City of Clyde Hill
Council Study Session

3.1. Update of Property Evaluation on Fire Station #5
[Clyde Hill Facilities Assessment](#)

RE Clyde Hill
City Hall and Maintenance Building Existing Conditions Review

This is a letter outlining our findings from our existing conditions review and ASCE 31-03 Tier 1 evaluation of Clyde Hill City Hall and Maintenance Building in Clyde Hill, Washington. We performed a site visit on October 5, 2016 and reviewed available existing documents. We reviewed the following documents:

Maintenance Building Floor Plan
 Seismic Recommendations

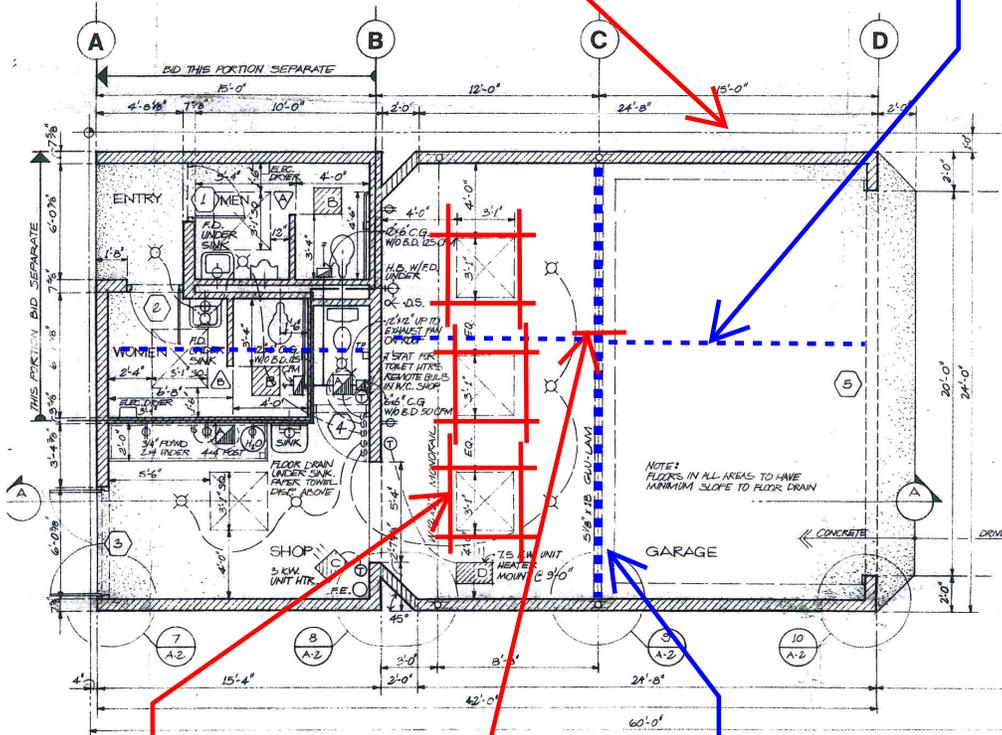
Comment 5:
 Add roof
 out-of-plane strap
 anchors at 4'
 on-center around
 all walls

Comment 7:
 Strap around
 skylights

Comment 6:
 Strap roof joists
 together

5. Out-of-plane brick masonry anchorage to the roof is deficient on all sides. The wall anchorage is required to prevent the masonry walls from pulling away from the roof.
RECOMMENDATION: Add strap anchors to connect the brick masonry walls to the roof at approximately 4' on-center.
6. There are no roof cross ties at the high roof in the east/west direction which reduces the factor of safety of the masonry walls pulling away from the roof.
RECOMMENDATION: Splice the 2x joist ends together where they bear on the glue-laminated beam.
7. Around the three skylights there is no reinforcement around the openings. There are high seismic stresses around these openings.
RECOMMENDATION: Add light gage straps over the sheathing on all sides of the skylights and extend approximately 2 feet past the openings.
